# CARRIAGE MEADOWS SOUTH FILING NO.2

## A PLANNED UNIT DEVELOPMENT & PRELIMINARY PLAN FOR CARRIAGE MEADOWS SOUTH AT LORSON RANCH FILING 2

PCD FILE NO.: PUDSP-19-5

PUD COVER SHEET & DETAILS P1 OF 10

### TYPICAL LOT DIAGRAMS

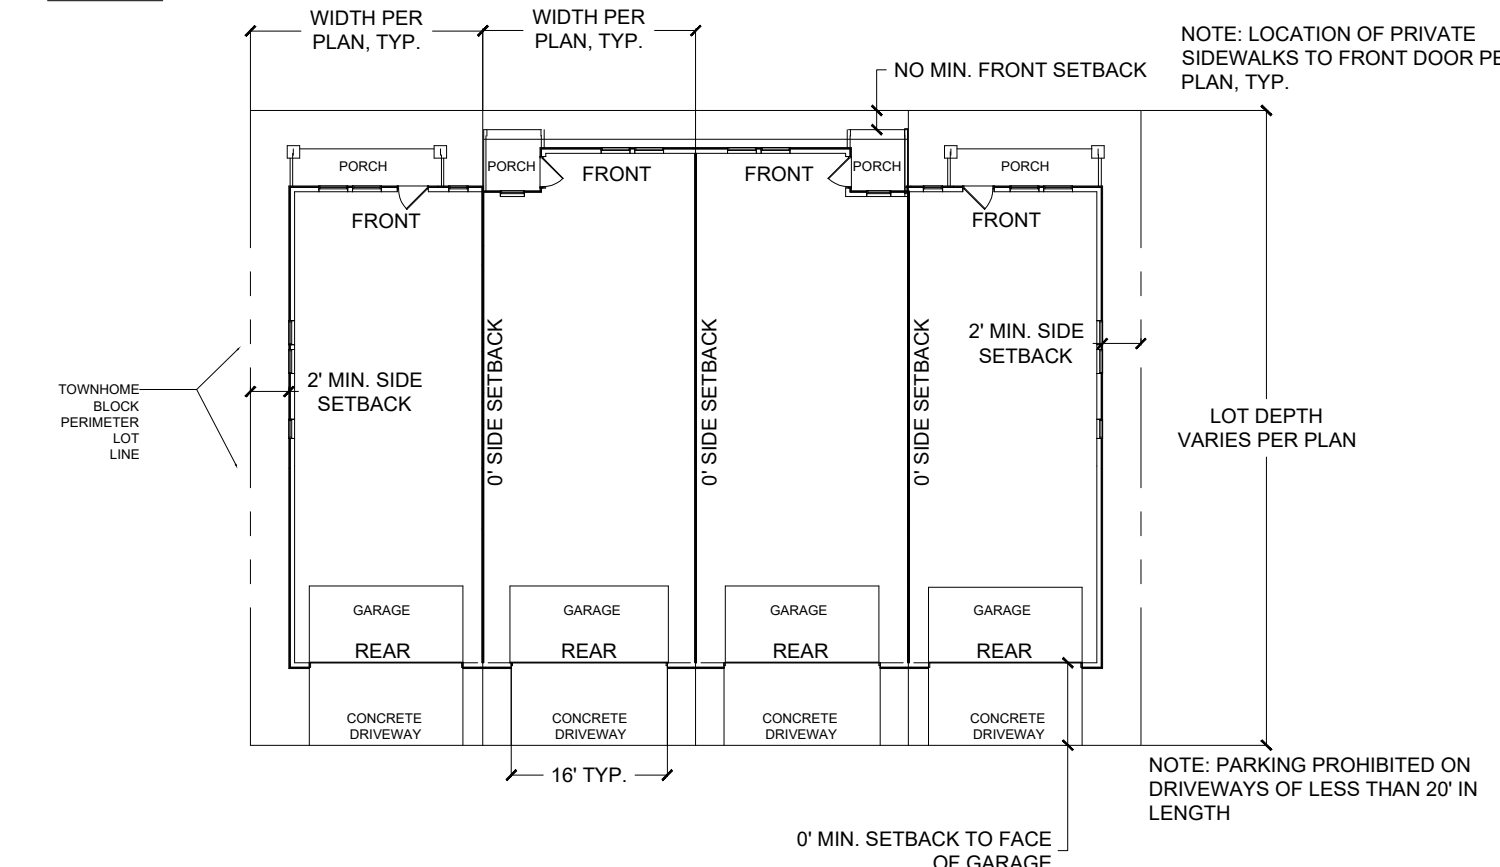
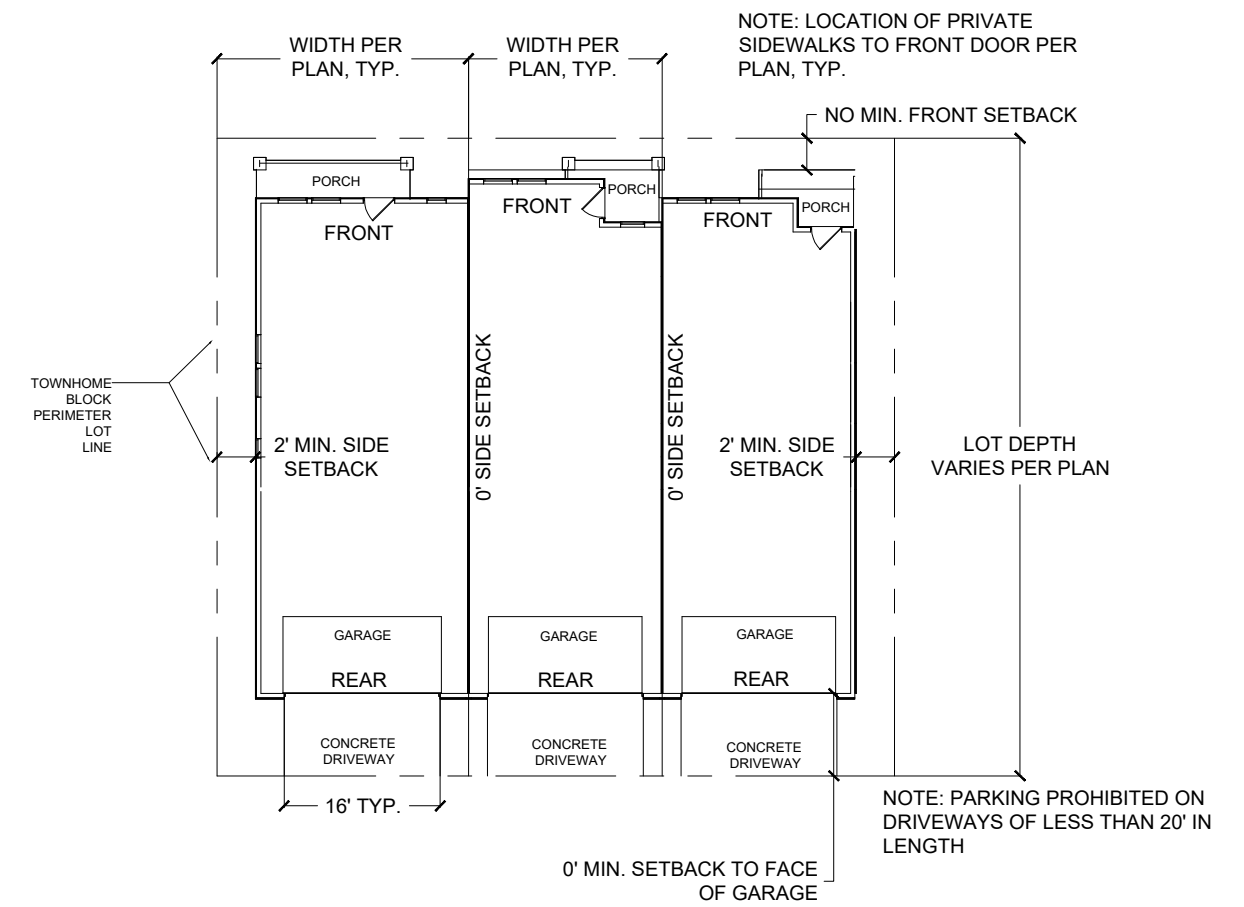
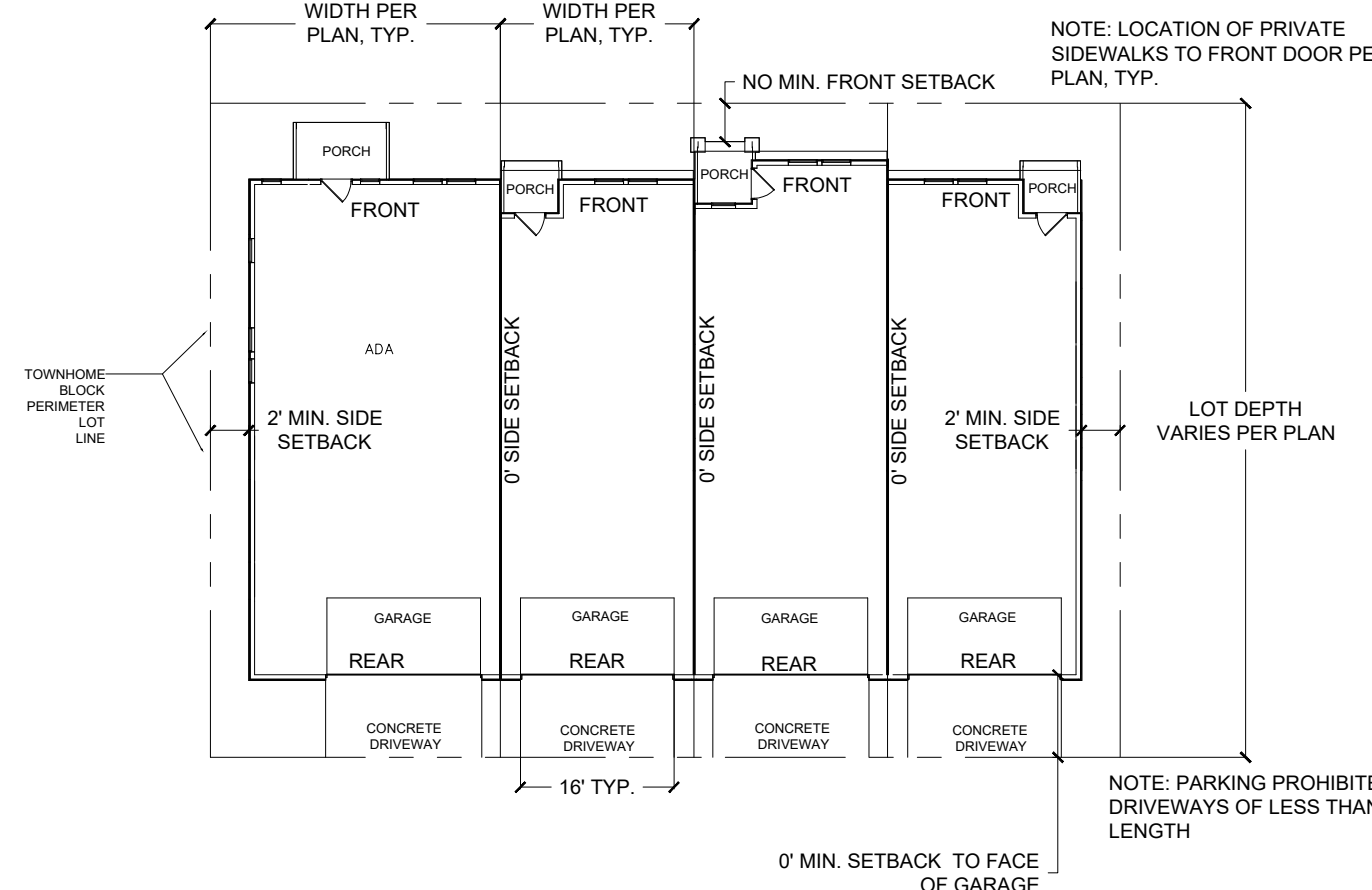
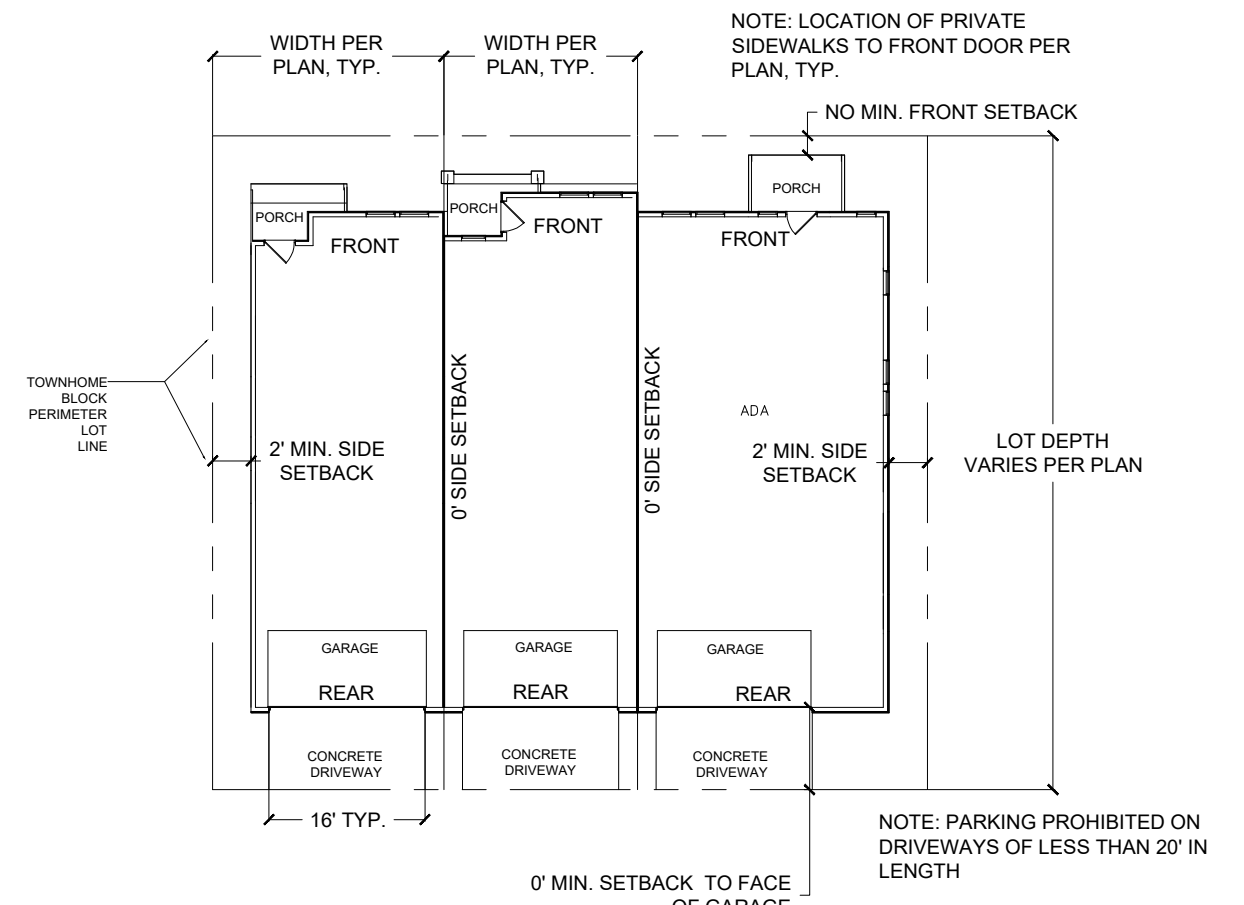
so if a driveway is 20-foot one can store their rv vehicle or boat?

dont repeat note on first page

### TYPICAL STREET CROSS-SECTIONS

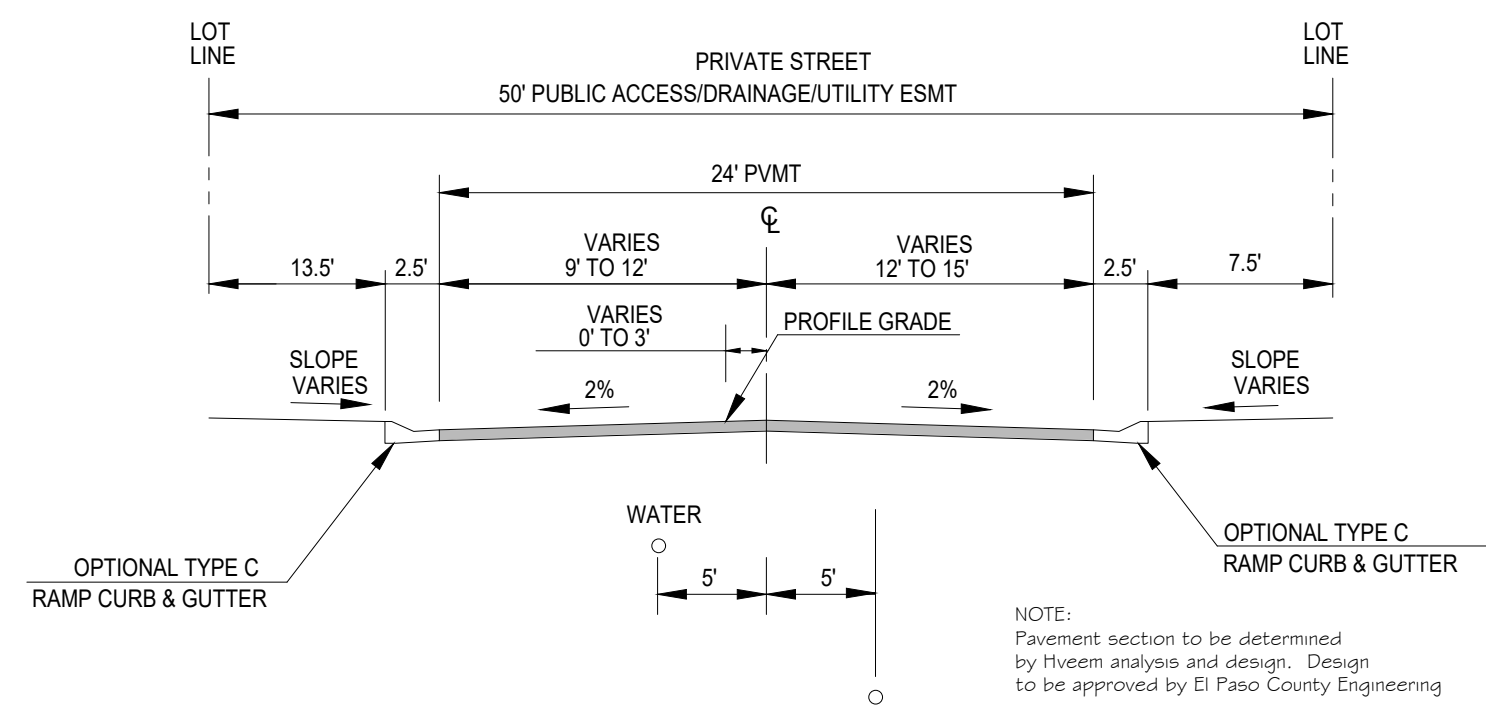
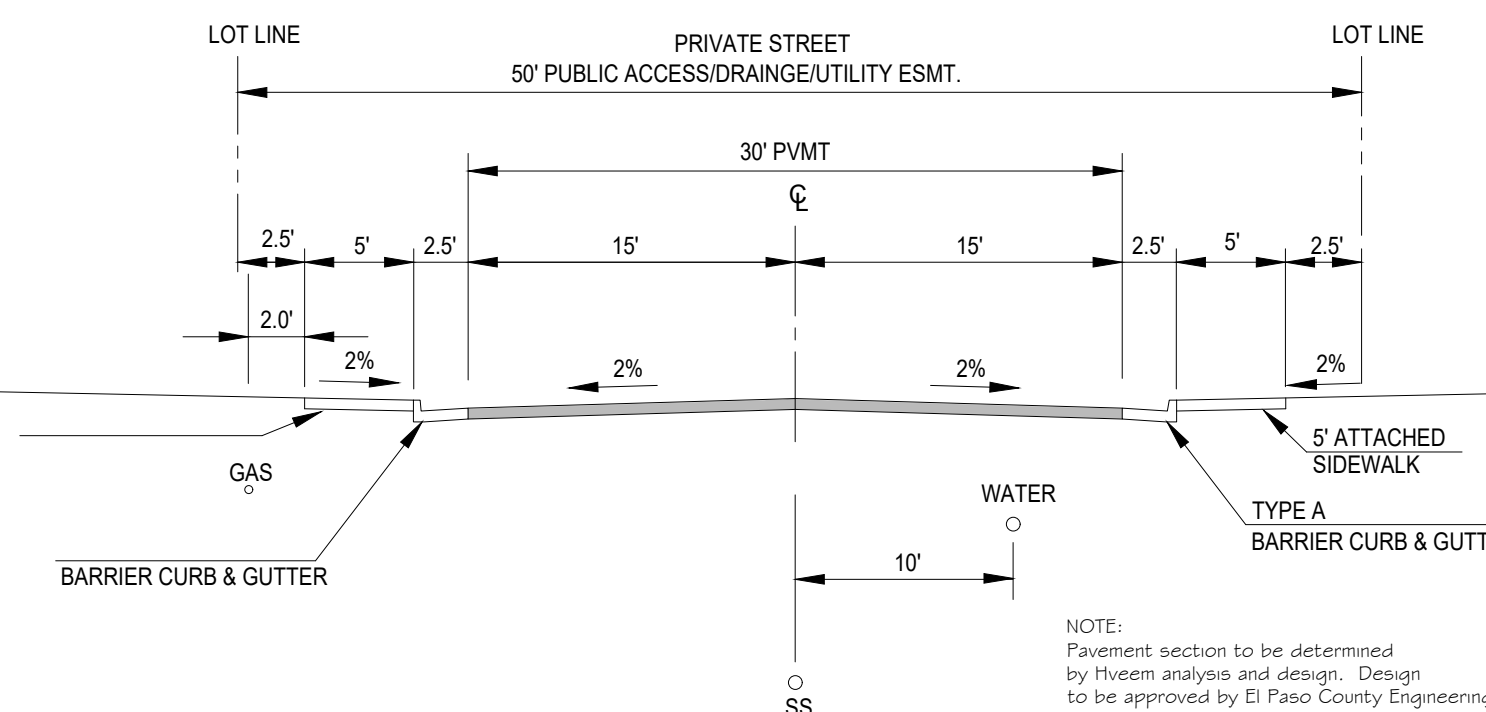
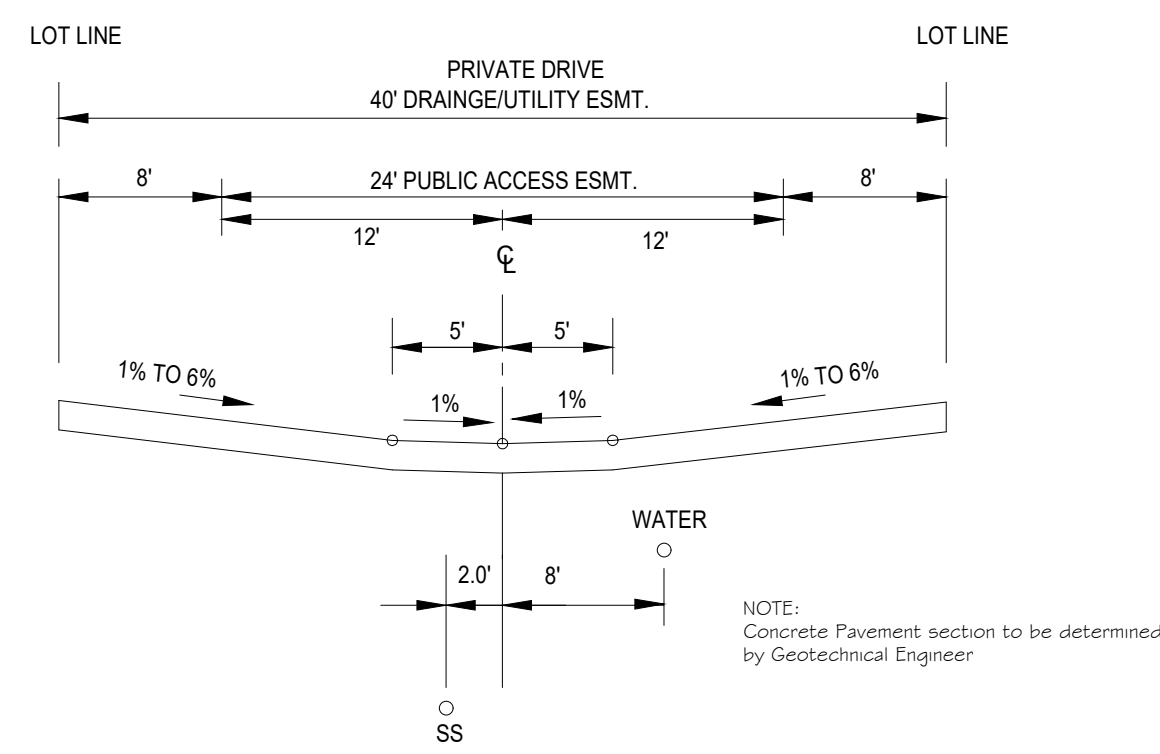
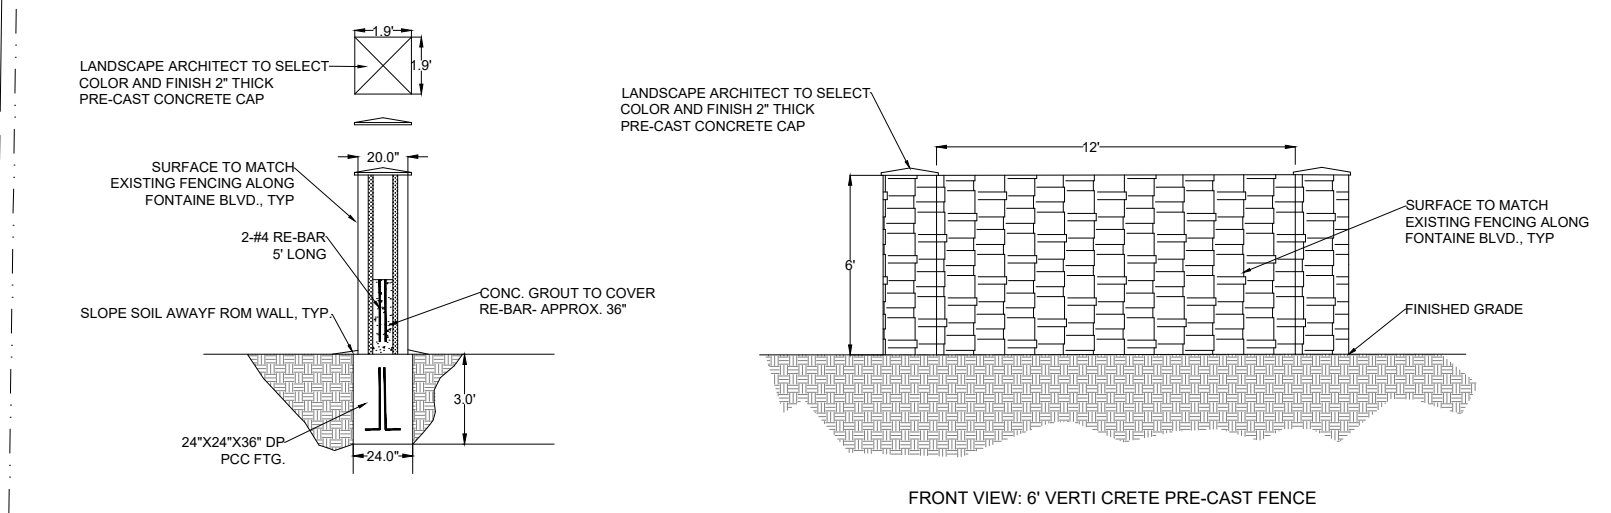
Provide all preliminary plan checklist items.
